**PORT COLBORNE**

**Subject: Stonebridge Village – Request to Modify Street Design**

Report Number: 2026-41

Figure 5: Proposed 18.0m Right of Way Cross Section (Streets, A,B,C,D)

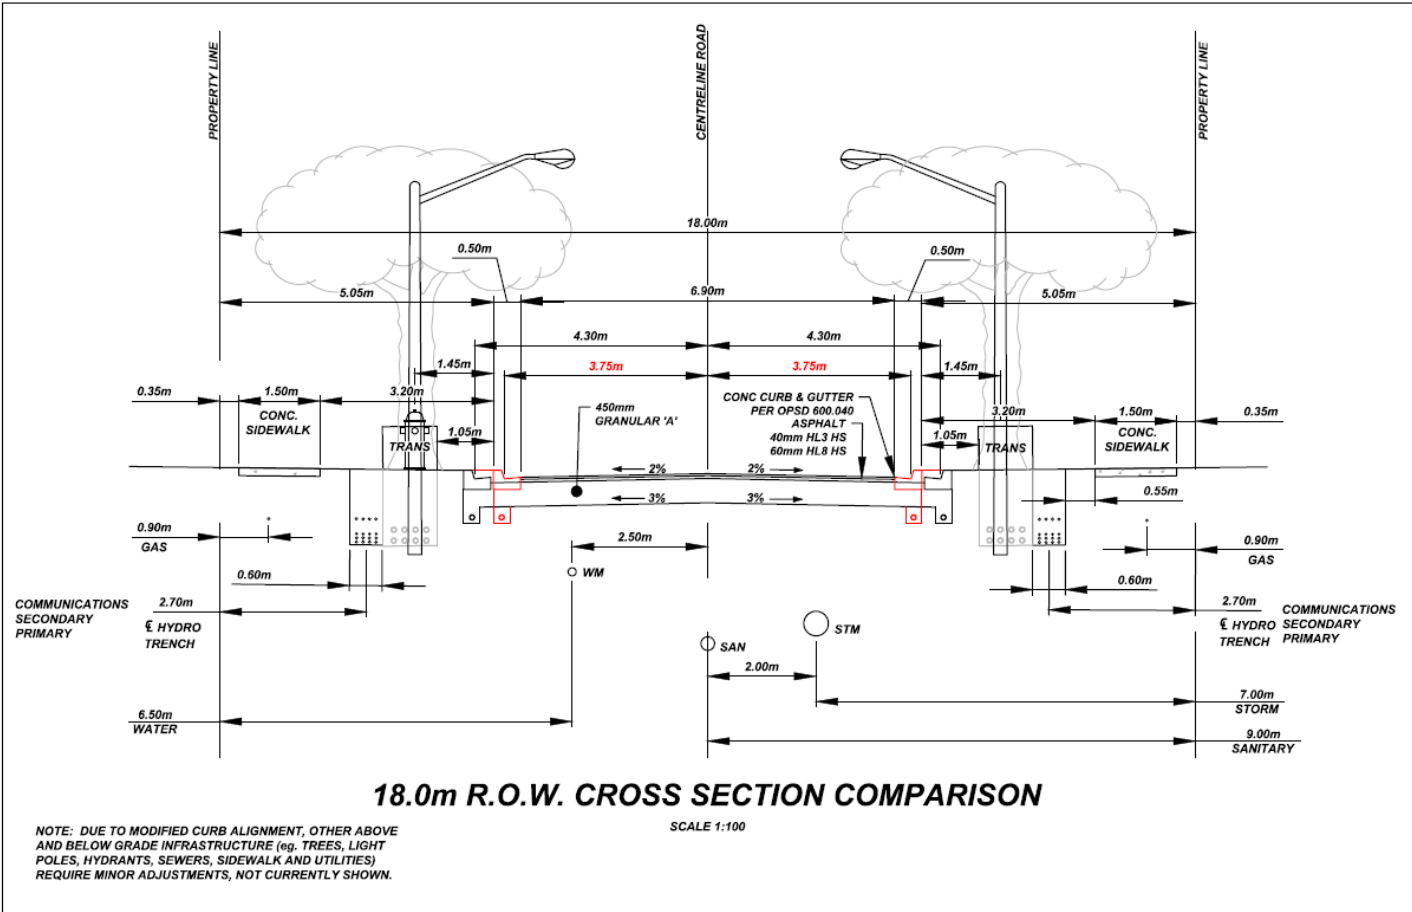
These streets have a ROW width of 18.0 metres, and the applicant is requesting a reduced street width from 8.6 metres curb face-to-curb face to 7.5 metres. This results in a lane width of 3.75 metres, as shown in the below cross section.

Request	Fire Comment	Public Works Comment	Planning Recommendation
Reduced Corner Radius (6 metres)	Not supported	Supported	Do not approve
Reduced Street Width (7.5 metres)	Supported	Supported	Approve
Curb Extensions	Not supported	Not supported *but could support with increased	Do not approve

That Council approve the proposed reduced curb face to curb face roadway widths of 7.5metres for Streets A-E of the Stonebridge Village Subdivision.

Figure 6: Proposed 20.0 metre cross section (Street E)

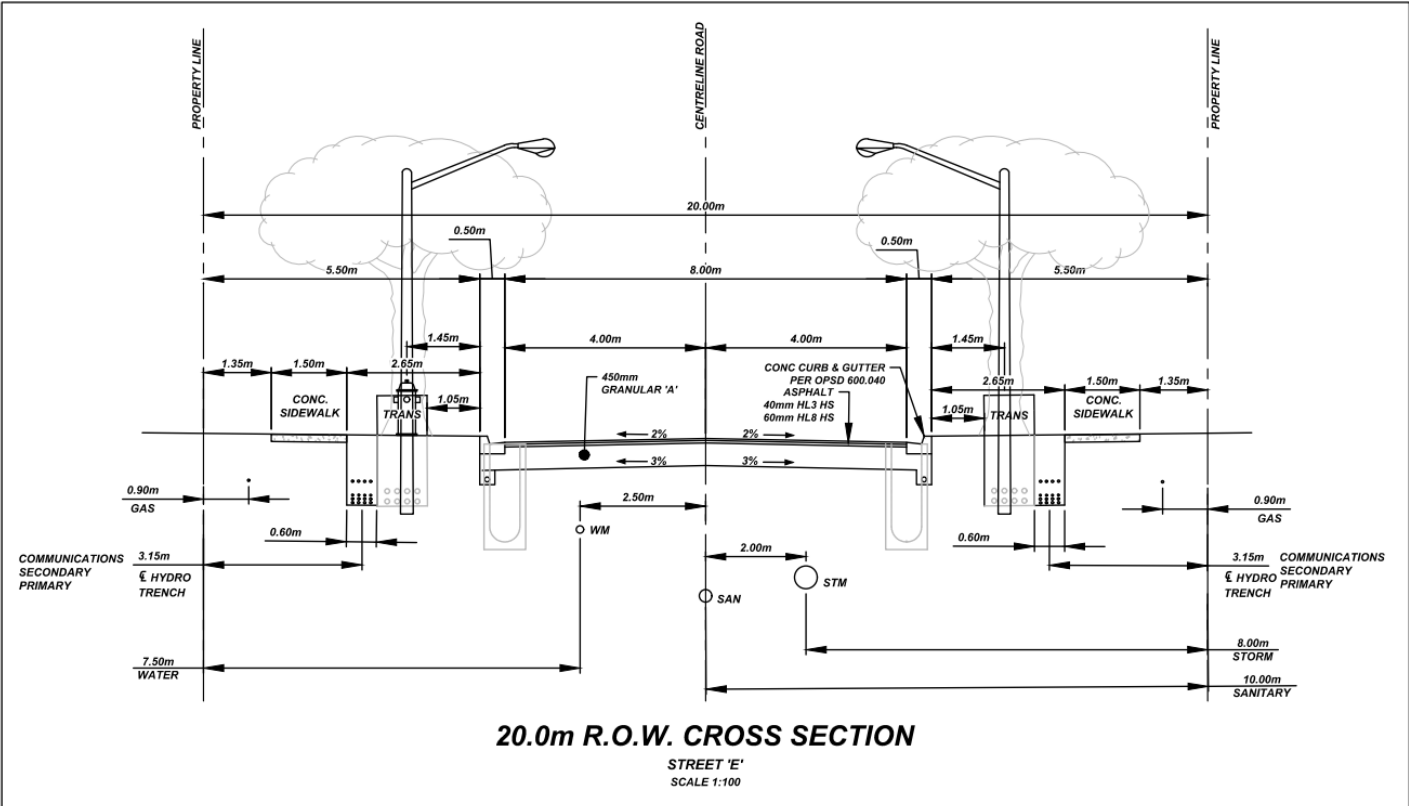
This street will have a 20.0 metre right of way, and the applicant is requesting a 7.5 metre cross section. This street will provide a connection from Barrick Road through the subdivision to the north. The applicant is also requesting to allow parking on both sides of this street. Figure 6 below shows the applicant's proposed cross section

intersection width and less abrupt bump out	
<b>Parking on Both Sides of Street E, between Streets B and D</b>	Not supported *but could support parking on 1 side	Not supported *but could support parking on 1 side	Approve parking on 1 side

Figure 7: Proposed Intersection Design

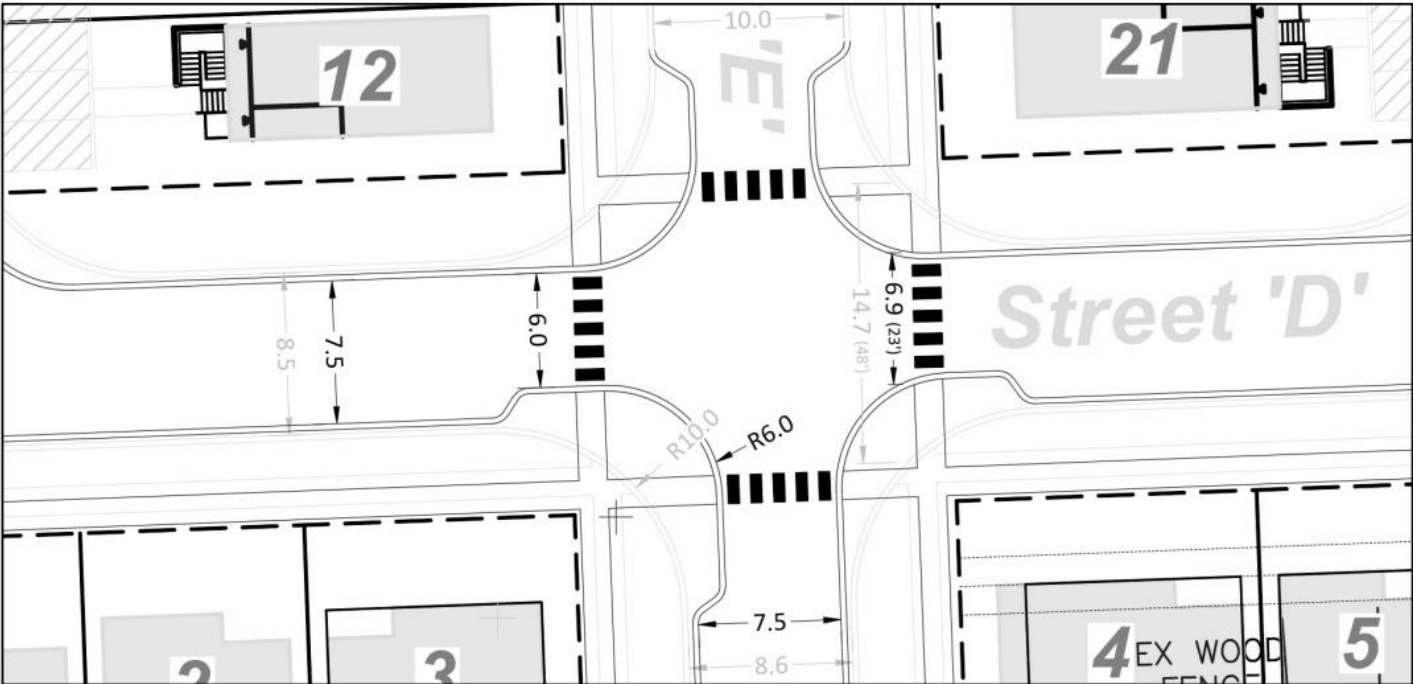
To reduce turning speeds in the subdivision, the applicant is proposing to reduce the corner radius from 9.0 metres to 6.0 metres. This also has the effect of reducing the land width at intersections.
